Additional Information

Dunedoo Solar Farm

June 2021

Project Number: 20-764

Figure 2-1 Dunedoo Solar Farm Topographical Map

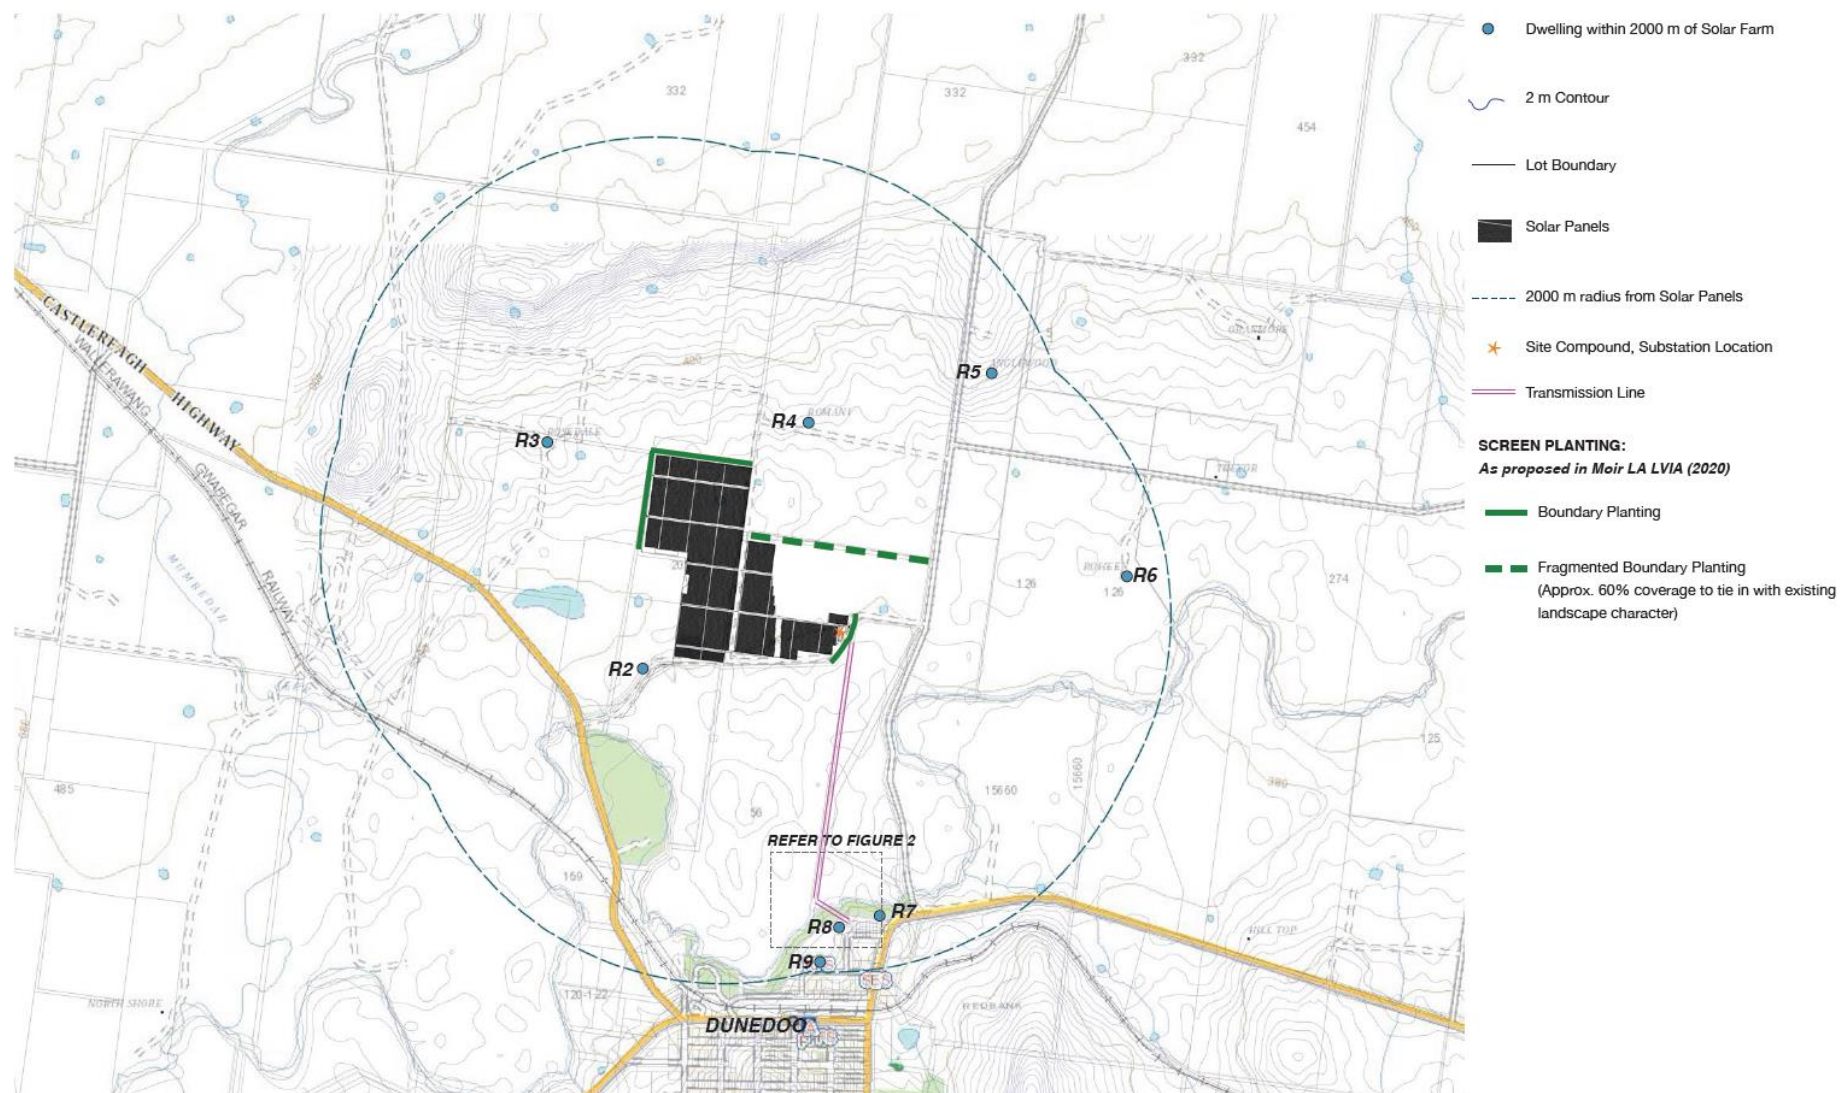
- o a clear description and evidence of the potential of the impacts on each receiver, including from residences R3 and R4 to R9 inclusive (such as representative viewpoints and photomontages);*
- o consideration of all elements of the project (including solar panels, on-site substation, inverters, communications tower, operations and maintenance buildings, transmission infrastructure, synchronous condenser, battery storage);*
- o topographical maps of the site and surrounding area for a 2 km radius; and*
- o details of the proposed measures to mitigate the potential impacts on receivers."*

A topographical map of the locality is presented Figure 2-1. The figure indicates that the area is relatively flat, as described within the executive summary, and in sections 3.1, 8.1.2, 8.2.3, 9.1.1, 9.6.2, 9.8.1, tables 8-17 and 8-18, on page 148, of the EIS. The utilisation of the topographical information and the full extent of the project. Appendix A provides this figure in higher resolution.

Figure 2-2 Proposed and existing elements of Dunedoo Solar Farm

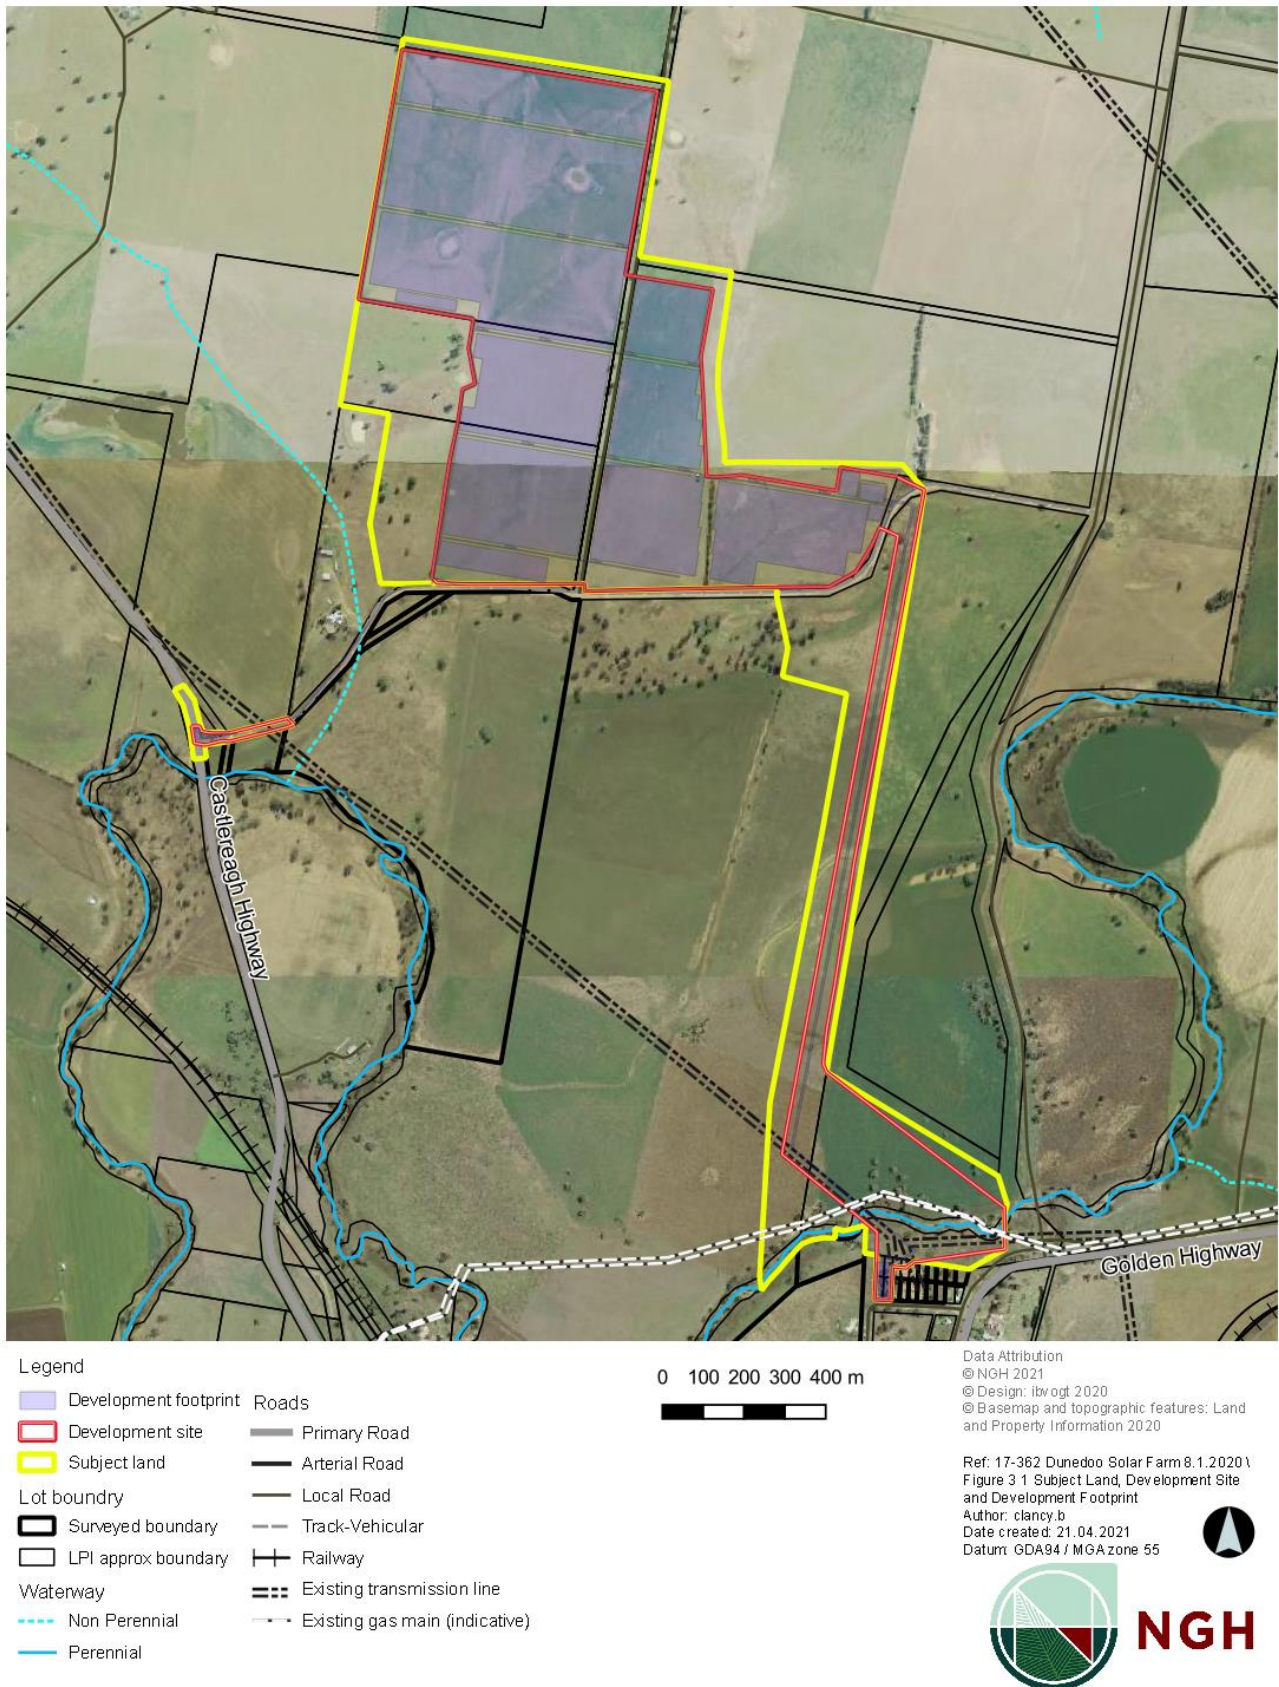
“...include the location of gas pipeline operated by the APA Group in the site layout plan, with this pipeline labelled as ‘high pressure gas transmission pipeline – no works without prior approval of APA.’ “

As indicated in the Preliminary Hazard Assessment (PHA) a high-pressure gas pipeline, operated by APA Group, traverses the development footprint, specifically under the proposed transmission line route, as shown in Figure 2-2 below. No works around the pipeline would occur without prior the relevant approval.

Lot 5 DP130930, as requested by DPIE to be inspected for the Schedule of Lands, is not part of the proposal. The site boundary sits on the southern edge of Lot 5 DP130930. Refer to Figure 2-2 above for details. The Proponent confirms that Lot 5 is not part of the Proposal.

Figure 2-3 Wind and solar developments surrounding Dunedoo Solar Farm

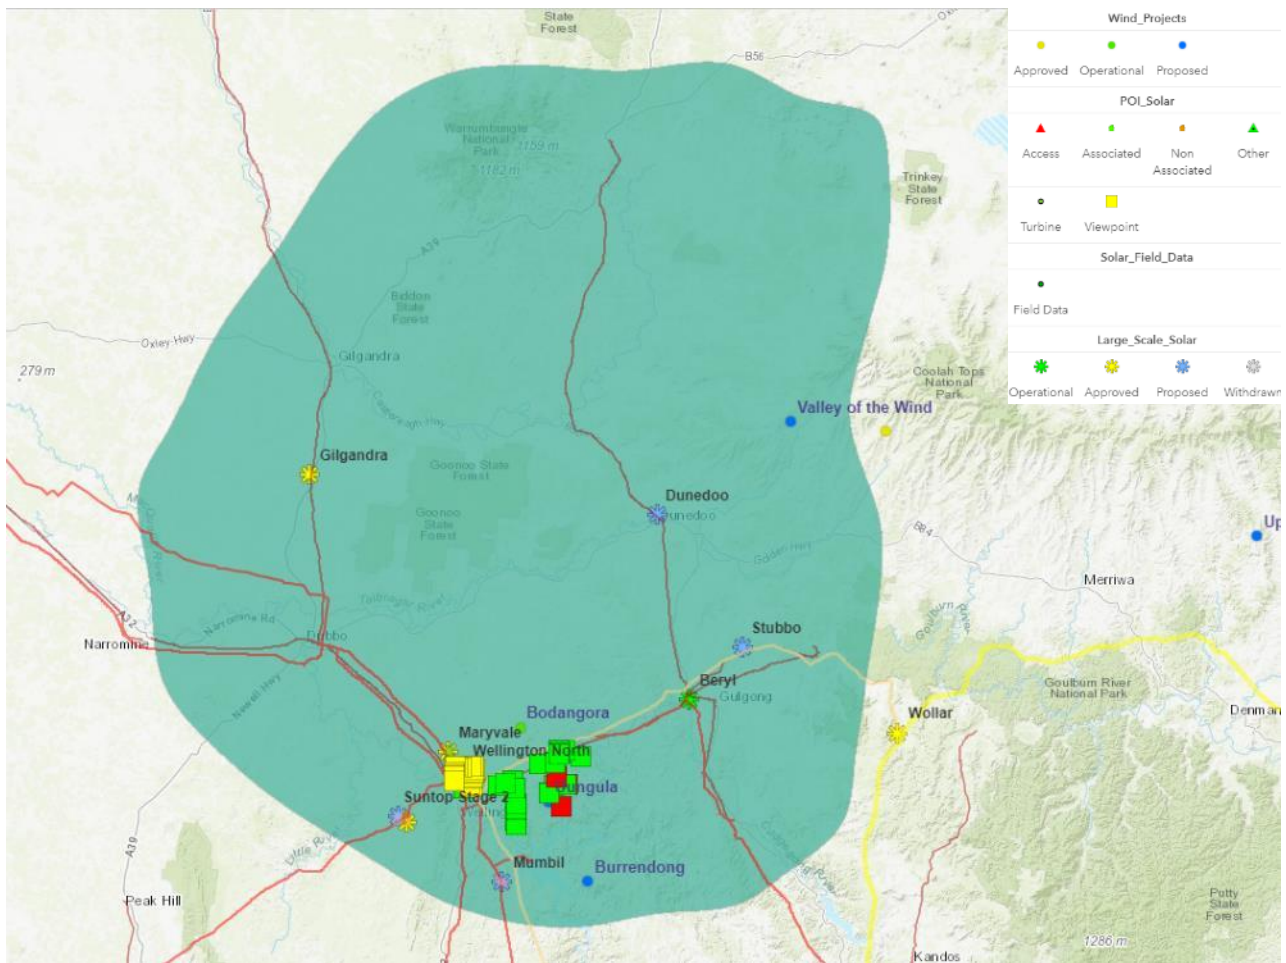
“Please include a further assessment of the potential cumulative impacts associated with other proposed / approved SSDs in the region (including any solar farms, wind farms and/or minerals mining projects), particularly regarding traffic / noise / amenity impacts, as well as impacts on local accommodation, infrastructure and services associated with the construction workforce. This should include consideration of any potential construction overlap associated with other projects in the region, as well as any mitigation measures proposed. Please also review the distances of these other projects from the proposal, as some of the distances referenced in the EIS with relation to the proposal are incorrect. I have attached a map that details some of the other projects in the area. While it is noted that there are several other SSDS in the region, you can focus primarily on the projects located within ~50km of the site (ie Stubbo, Beryl, Valley of the Wind, Bodangora, Liverpool Range) whilst still also referencing / considering the others in the area. I’m happy to clarify further if required.”

DPIE’s list of projects shown in Table 2-1 below and shown within the Central West Orana REZ in Figure 2-2 below., updates the distances presented in the EIS, and are mostly located south of the Dunedoo site. Valley of the Winds windfarm is the closest proposal at 15km to the east while Liverpool Range Windfarm and Stubbo Solar Farm, are further away located approximately 40 km from the Proposal. These three site could have overlapping construction periods with the Proposal and are therefore most likely to result in cumulative impact.

Figure 2-4 Proposed lot consolidation plan

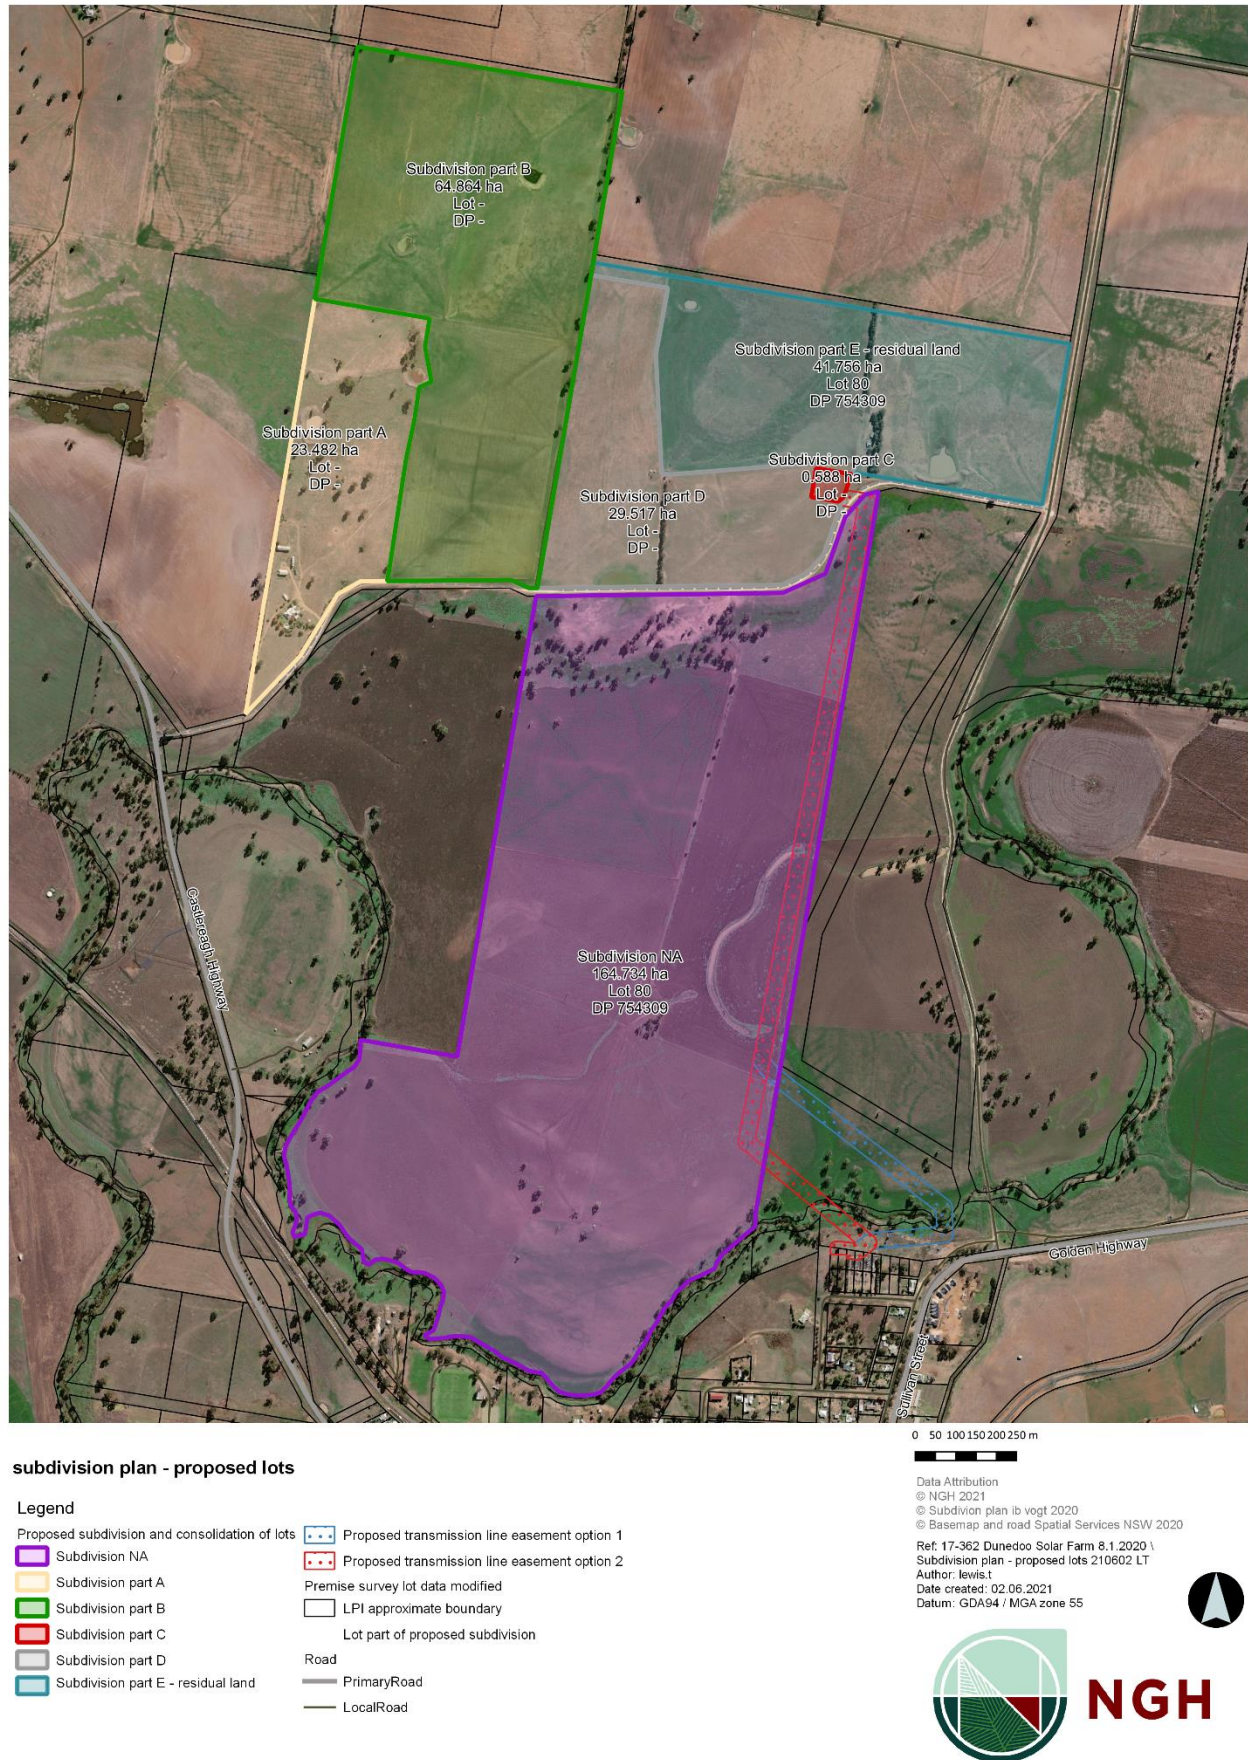
“Please provide a higher resolution subdivision plan that clearly identifies the subdivision proposed, together with a table listing existing lots (including lot size) and proposed lots (including lot size).”

Refer to Figure 2-4 for the proposed lot consolidation in higher resolution in Appendix C .

Figure 2-5 Proposal Infrastructure Lay-out

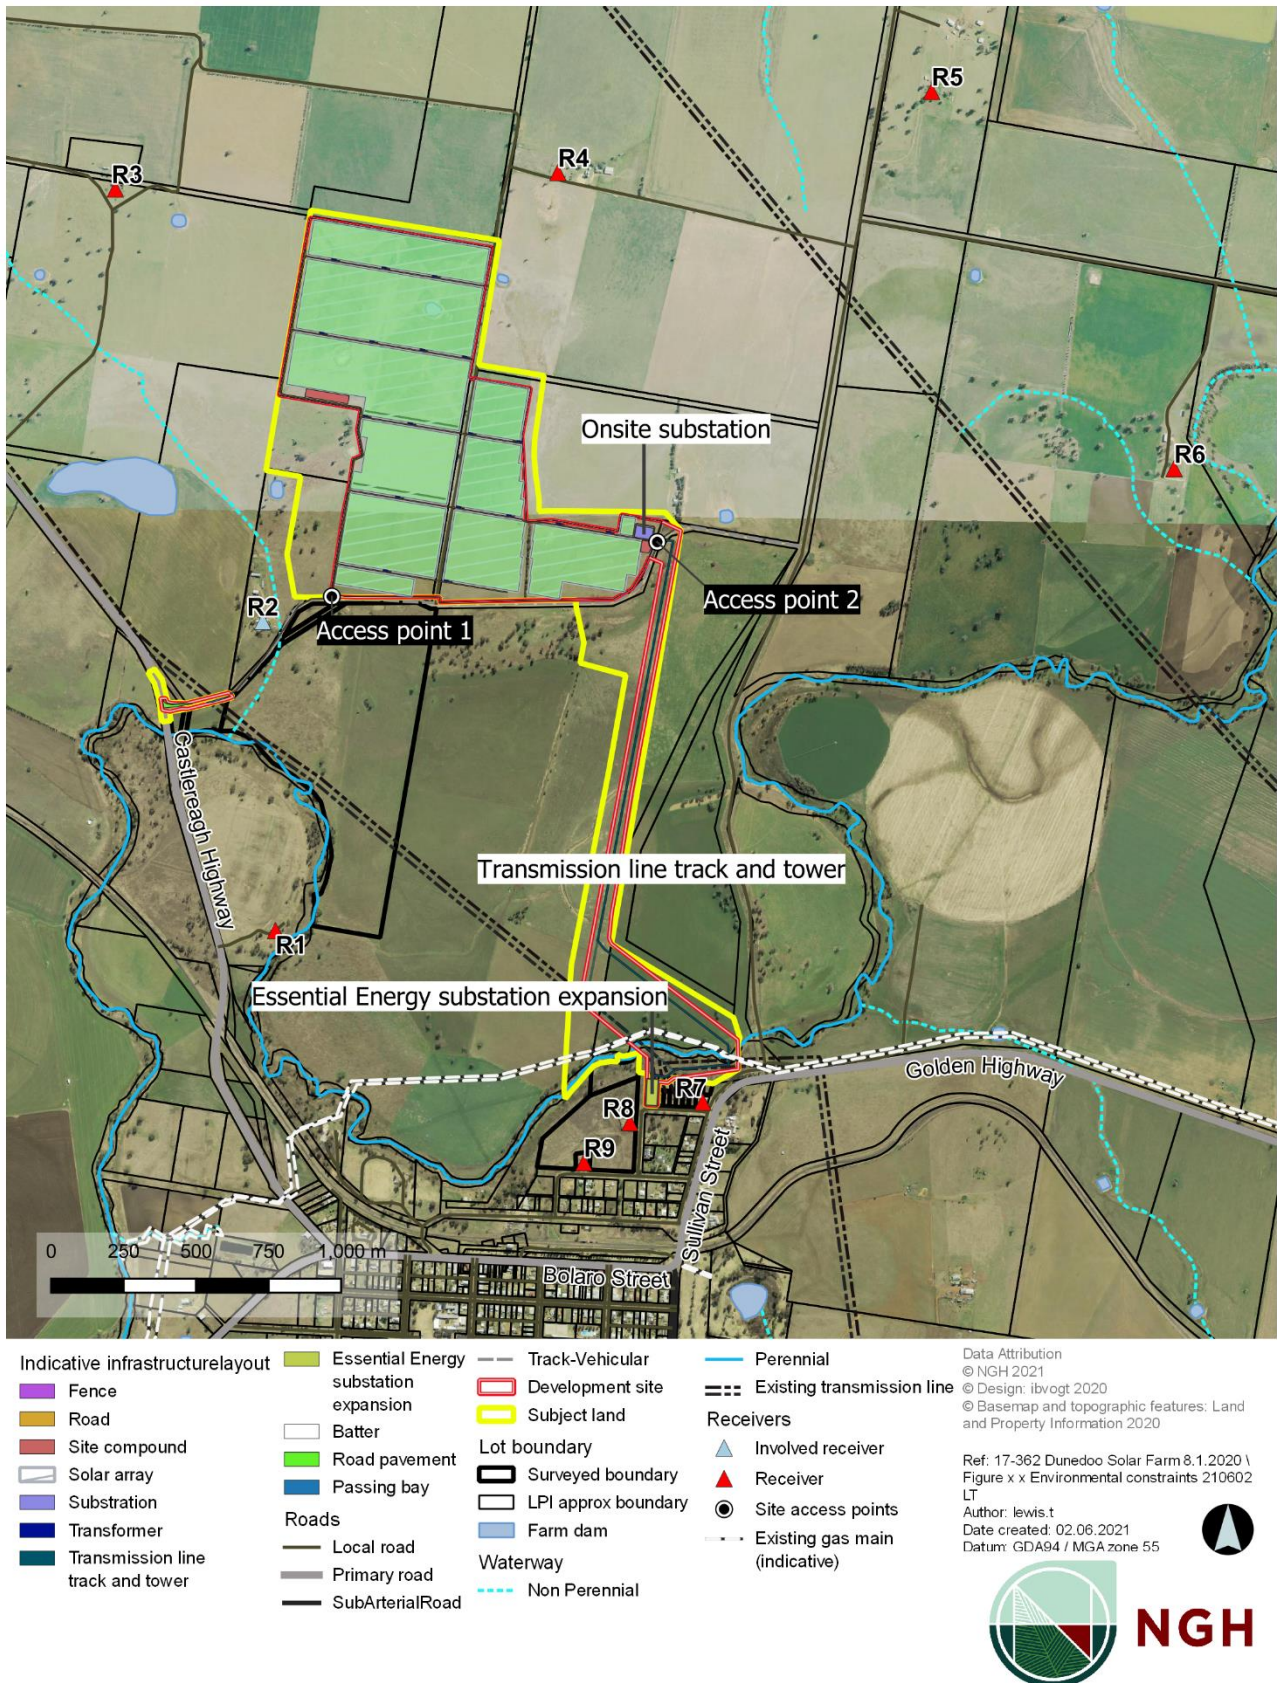
“Access to transmission line options 1 and 2 provide details of the site access points proposed for the transmission lines.”

“Please update site layout / infrastructure plan to clearly identify all proposed infrastructure”

Access to both transmission line options on Lot 80 DP754309 will be provided through the entry south from All Weather Road under the powerline, as indicated in Figure 4-1 of the EIS and replicated as Figure 2-5 in this document.

The proposed site layout of Dunedoo Solar Farm is presented in Figure 2-2 above. Figure 4-1 in the EIS provided a comprehensive detail of proposed infrastructure with Figure 2-5 below (replicated in Appendix E) showing proposed infrastructure. In addition, Figure 2-6 to Figure 2-8 show the site layout during construction, operation, and specifically the transmission line options where it would traverse Talbragar River. This has remained the same since the lodgement of the EIS.
